## TOWN CENTER BUILDING A.1 JSP 17-24

Approval at the request of Novi Town Center Investor, LLC for Preliminary Site Plan and Section 9 Façade Waiver. The subject property is located in Section 14, north of Grand River Avenue and east of Novi Road. The subject property is approximately 47.77 acres and in the TC, Town Center District. The applicant is proposing to update the façade by removing the existing storefront canopy and construct a new façade on the one story retail building.

# PLAN REVIEW CENTER REPORT

Re: FACADE ORDINANCE – Final Site Plan Review  
**Town Center Building A.1, JSP17-0024, PSP17-0035**  
 Façade Region: 1, Zoning District: TC

**WEST ELEVATION**  
SCALE: 1/8" = 1'-0"

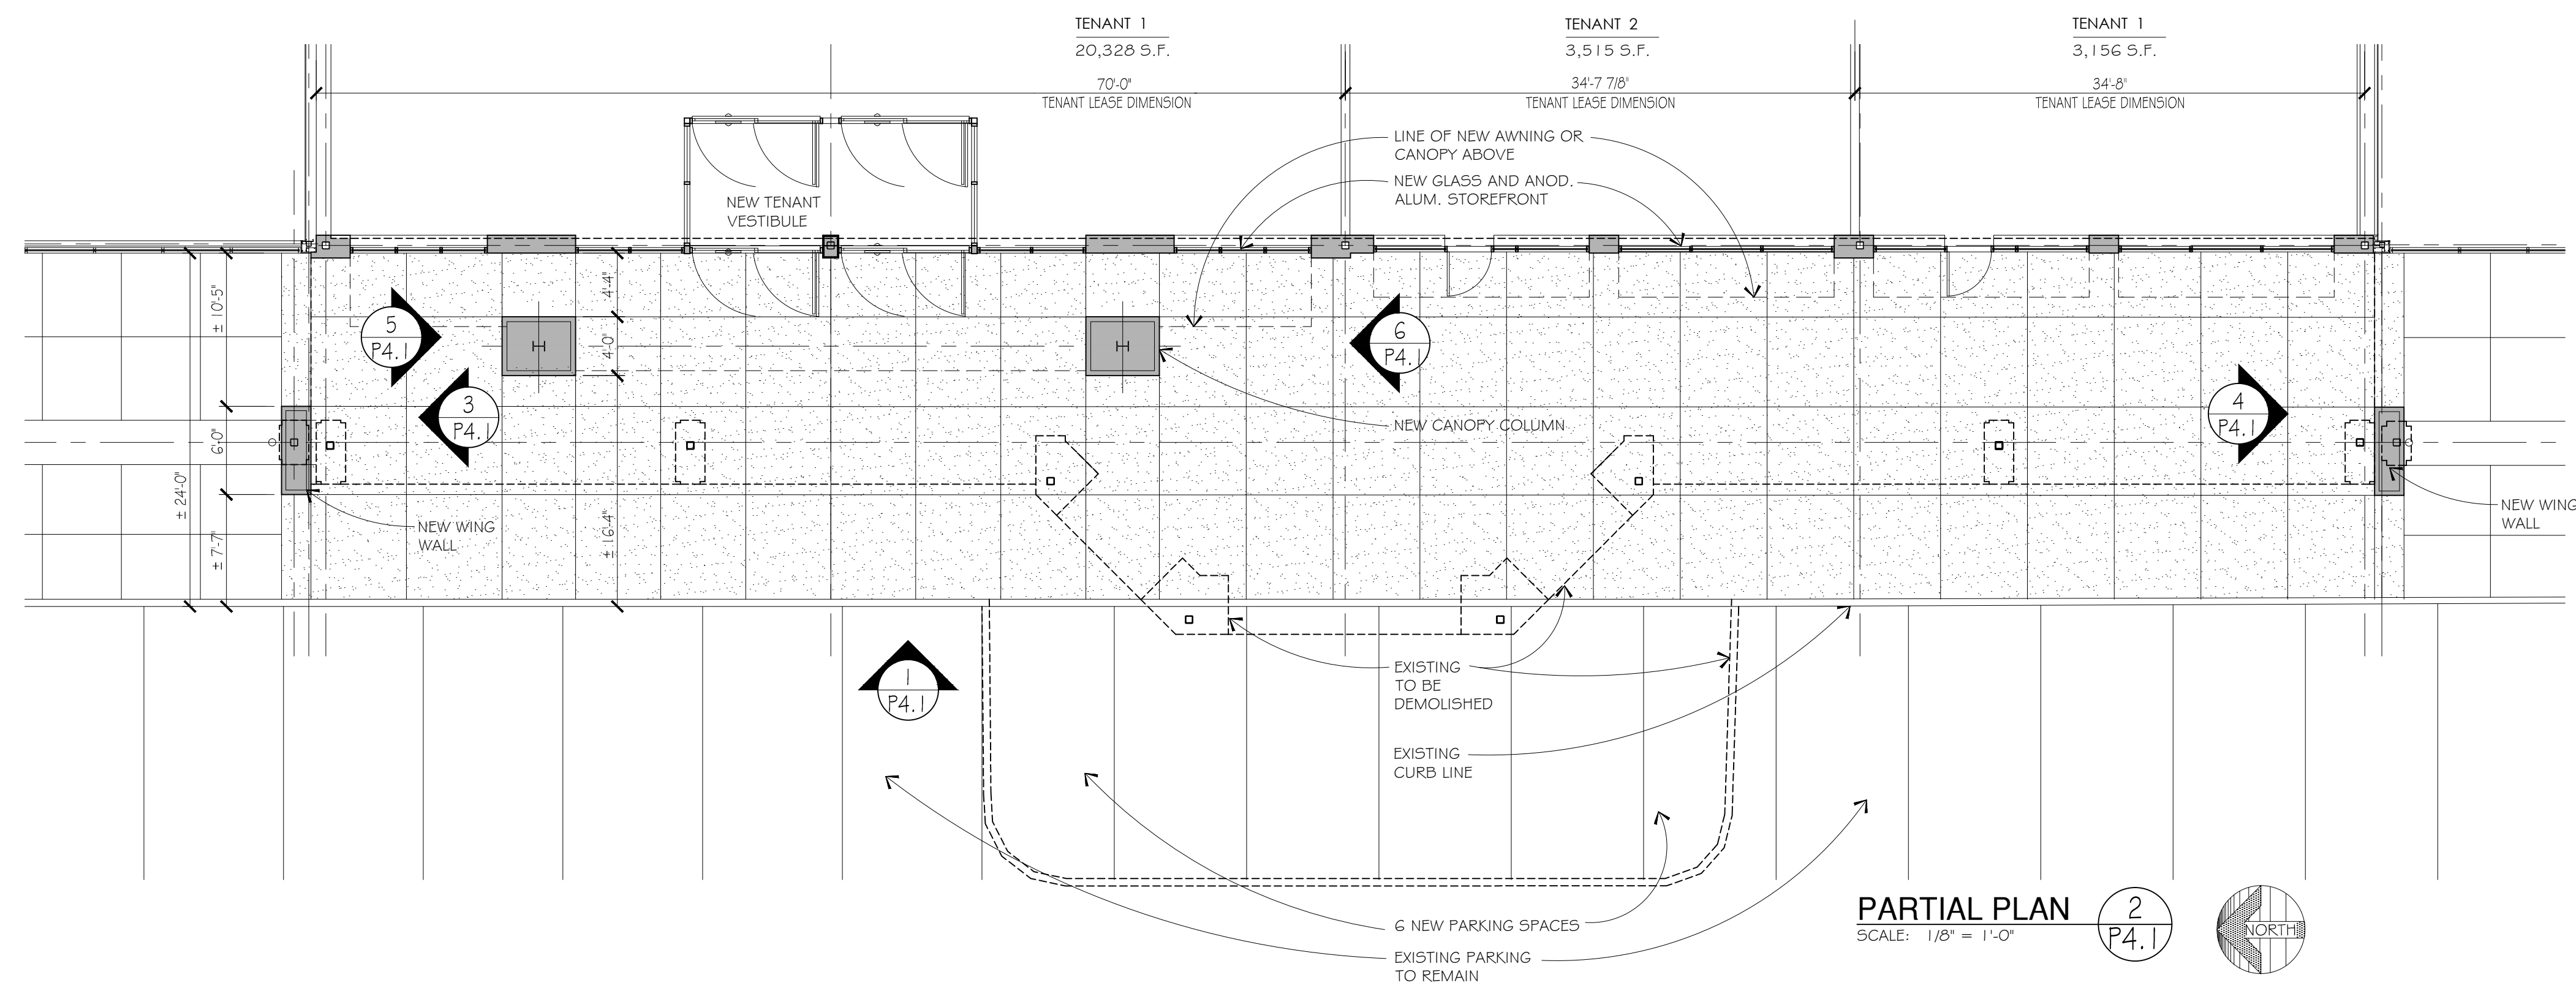
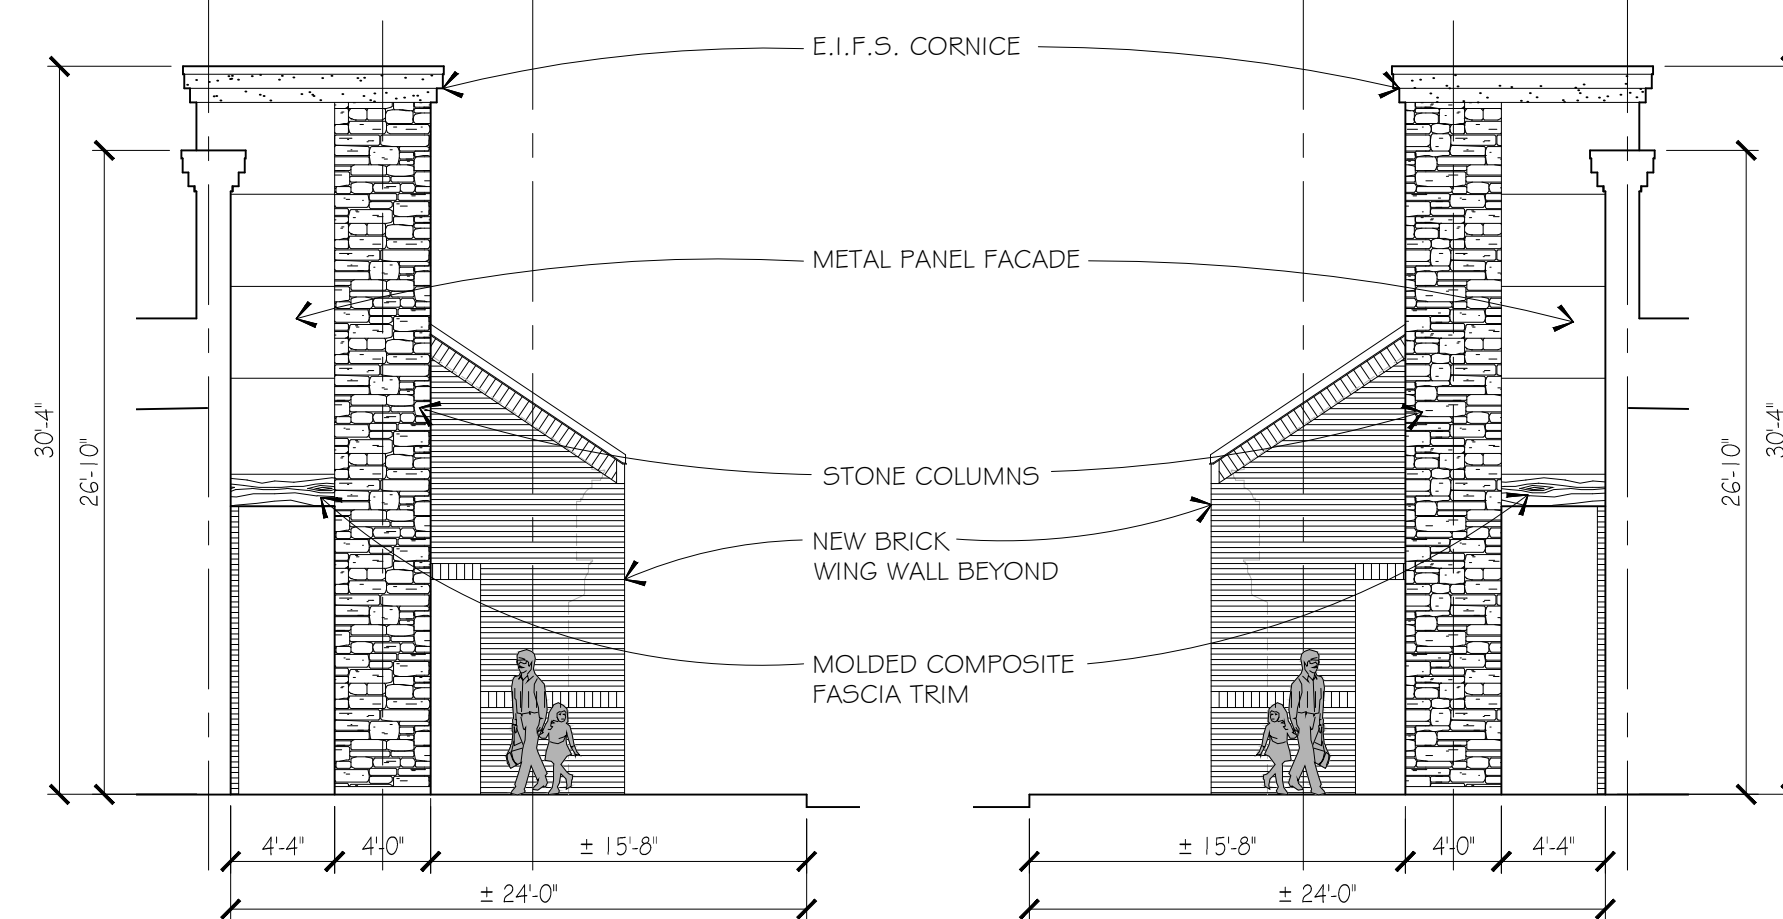
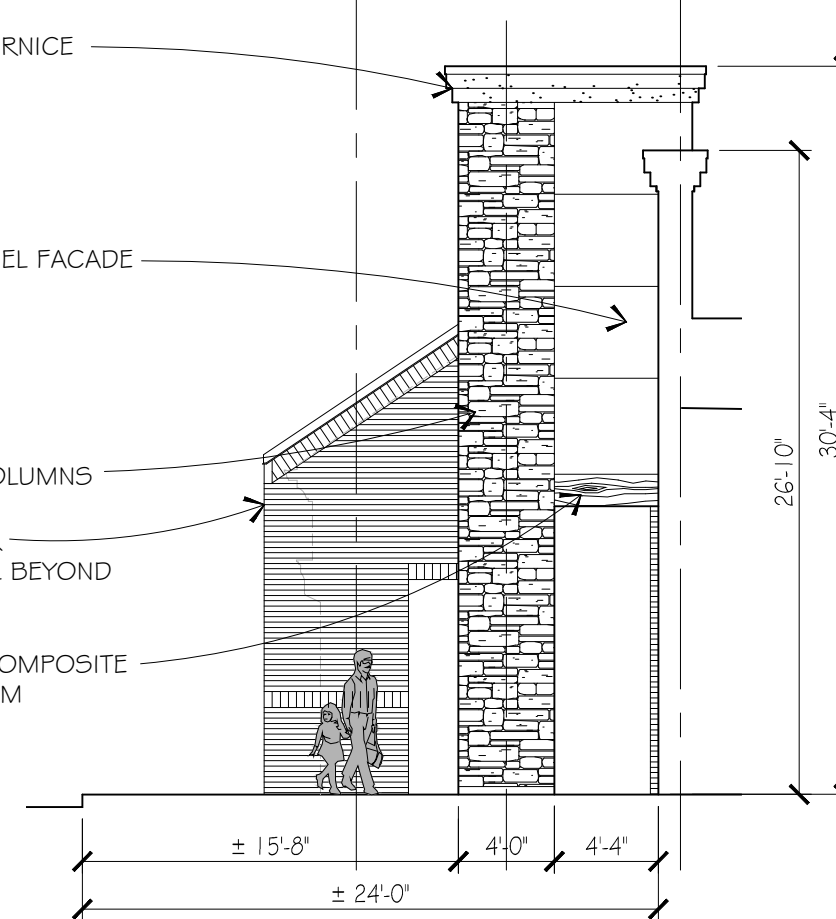
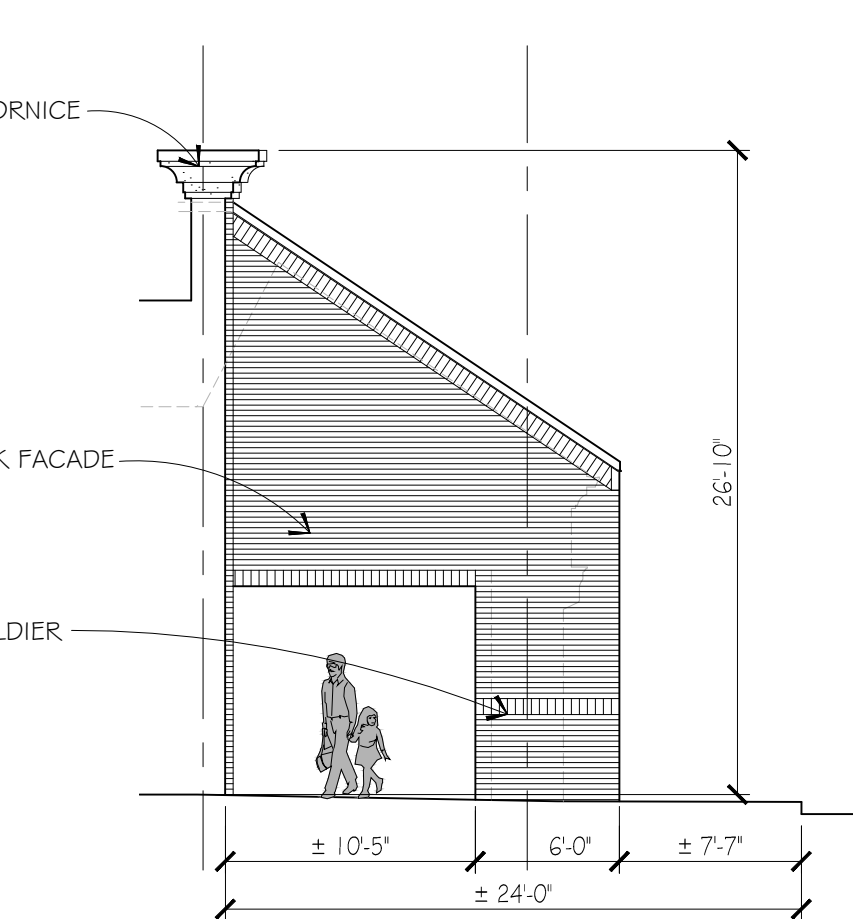
West (Front)	North	South	East	Façade Ordinance Section 2520 Maximum (Minimum)
Brick (Exiting, unaltered)	36%	94%	94%	N/A	100% (30% Min.)
Cultured Stone	11%	0%	0%	N/A	50%
Standing Seam Metal	13%	0%	0%	N/A	25%
EIFS	14%	2%	2%	N/A	25%
EIFS Cornice (Molding)	5%	4%	4%	N/A	15%
Wood Trim (Beam)	<b>2%</b>	0%	0%	N/A	0%
Flat Metal Panels	<b>19%</b>	0%	0%	N/A	0% (Footnote 10)

This application consists of an alteration to an existing building as regulated by Section 5.15.6 of the Façade Ordinance. As shown above, the percentages of Wood Trim and Flat Metal Panels exceed the maximum amounts allowed by the Ordinance. The proposed alteration is consistent with Section 3.27.G of the TC Ordinance which requires that facades be primarily Brick and Stone

**Recommendation** – The use of Flat Metal Panels and Wood Trim within the context of the proposed alteration is consistent with the intent and purpose of the Façade Ordinance. Amendments to the Façade Ordinance currently under consideration would allow 10% of this material in the TC District. For the reasons stated above, it is our recommendation that a Section 9 be granted for the overage of Flat Metal Panels and Wood T rim.

1. A Section 9 waiver for wood trim and flat metal panels is requested, and recommended for approval.

**PARTIAL PLAN**  
SCALE: 1/8" = 1'-0"

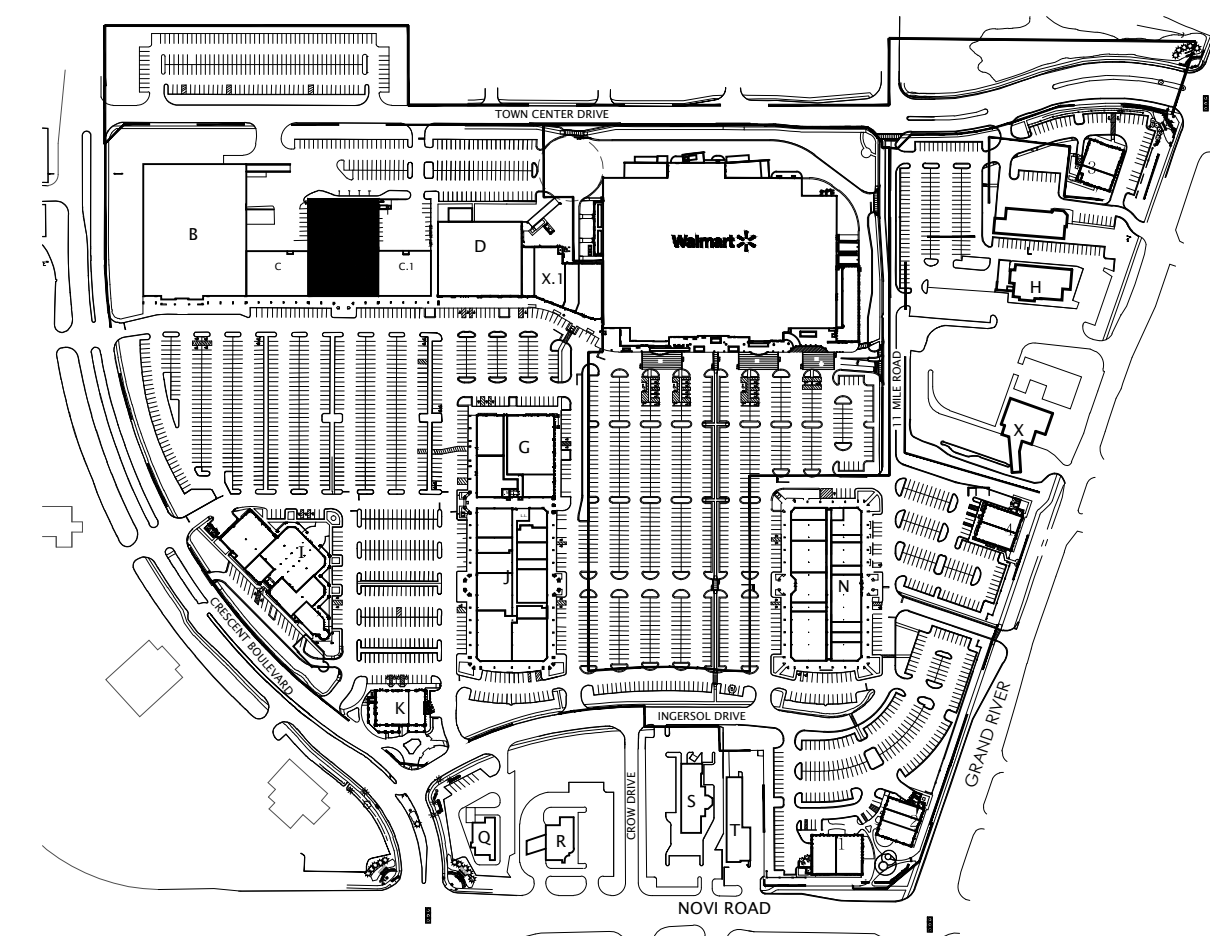
2. Parking Spaces Dimensions (Sec. 5.3.2): 90° Parking requires 9 ft. x 19 ft. dimensions or 9 ft. x 17 ft. parking with 7 ft. wide interior sidewalks as long as detail indicates a 4" curb at these locations. **The applicant should provide the new parking space dimensions, proposed curb height, and sidewalk width labels in order to confirm the spaces meet standards.**

1. 6 new parking spaces are added in the area where an existing concrete island is being demolished. The new parking spaces will be 9' x 18'-6" to match existing spaces along the sidewalk. There will be approximately 15'-2" clear from the back of the new 6" curb, to the face of the new canopy feature columns.
